Blair Greimann
 Technical Services Center, Bureau of Reclamation
 Denver, CO
 1-31-2012

Errata to: Reclamation (2011). “Hydrology, Hydraulics and Sediment Transport Studies for the Secretary’s Determination on Klamath River Dam Removal and Basin Restoration,” Technical Report No. SRH-2011-02. Prepared for Mid-Pacific Region, US Bureau of Reclamation, Technical Service Center, Denver, CO.

Figure 9 21. Sediment delivery to the ocean under Scenario 8 and with dams in place (No Action) for the year of dam removal. Note: these results are only valid for the year of dam removal. No significant increase in sediment loads is predicted for years following dam removal.

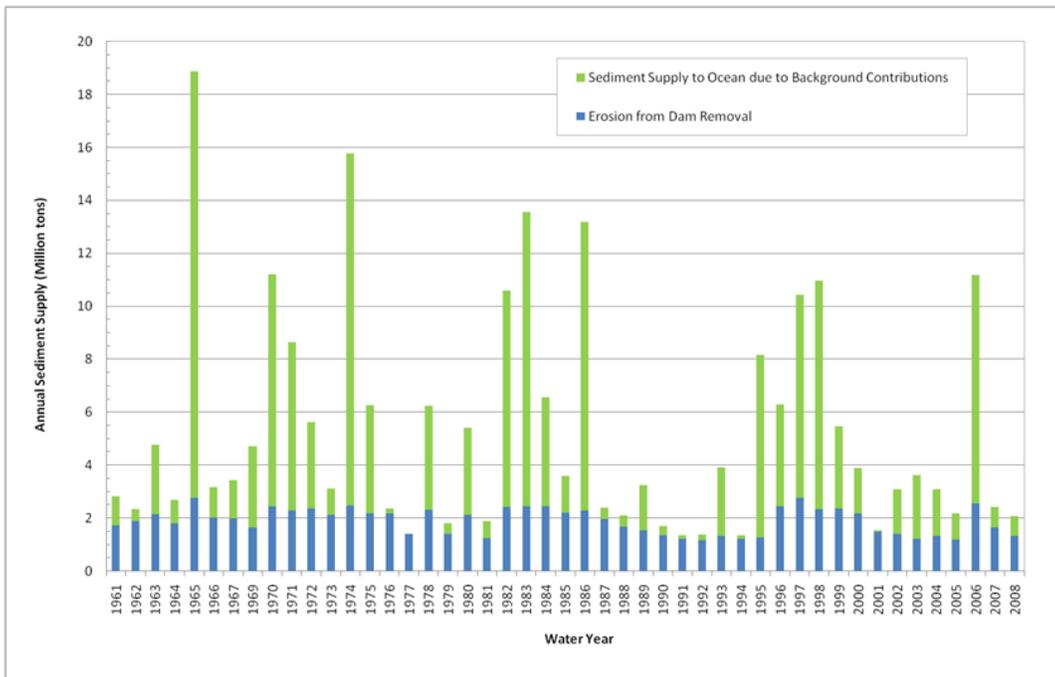
1. Figure 9-21 should be replaced with the following figure:
